Access Compliance Report

Public Rights-of-Way

Intersection ID: 49698	Main Street: LOUGHLIN_LN	Cross Street: MADISON_HILL_CT	Location: E
ADA ID: 40910A40BF08	Ramp Type: PerpDiag	Initial Pass/Fail: Fail	Overall Compliance: No
Severity Score: 12.5			
Codes/Mitigation Info/Possible Solution		Field Measurements/Component Compliance

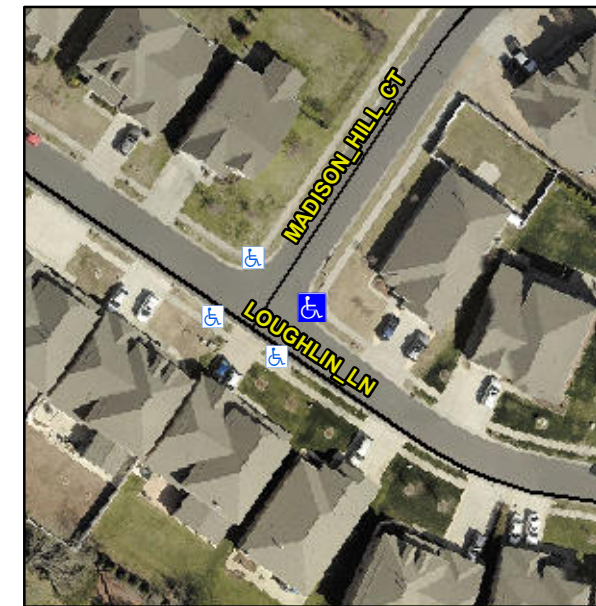
Not Found, R304.2.2

Compliance	Description	Data	Compliance	Description	Data
N/A	Ramp Length (in)	47.0	No	Ramp Slope (%)	10.5
Yes	Ramp Width (in)	48.0	Yes	Ramp XSlope (%)	1.3
N/A	Flare Type LT	N/A	N/A	Flare Type RT	N/A
N/A	Flare Slope LT (%)	N/A	N/A	Flare Slope RT (%)	N/A
N/A	Flare Traversable LT?	N/A	N/A	Flare Traversable RT?	N/A
N/A	Landing Length (in)	N/A	N/A	DWS Provided?	N/A
N/A	Landing Width (in)	N/A	N/A	DWS Contrast?	N/A
N/A	Landing Slope (%)	N/A	N/A	DWS Length (in)	N/A
N/A	Landing X Slope (%)	N/A	N/A	DWS Full Width?	N/A
N/A	Landing Curb? (Y/N)	N/A	N/A	DWS Offset (in)	N/A
N/A	Shared Landing?	N/A			
N/A	Gutter Ponding?	N/A	N/A	Gutter Slope (%)	N/A
N/A	Gutter Lip Ht (in)	N/A	N/A	Gutter X Slope (%)	N/A
N/A	Painted X Walk1?	No	N/A	Painted X Walk2?	No
	X Walk 1 Direction	To NW		X Walk 2 Direction	To SW
N/A	X Walk 1 Width (in)	N/A	N/A	X Walk 2 Width (in)	N/A
	X Walk 1 Slope (%)	2.5		X Walk 2 Slope (%)	0.0
	X Walk 1 X Slope (%)	0.0		X Walk 2 X Slope (%)	1.8

Remove & Replace Curb Ramp With Two New Directional Ramps or Equivalent.
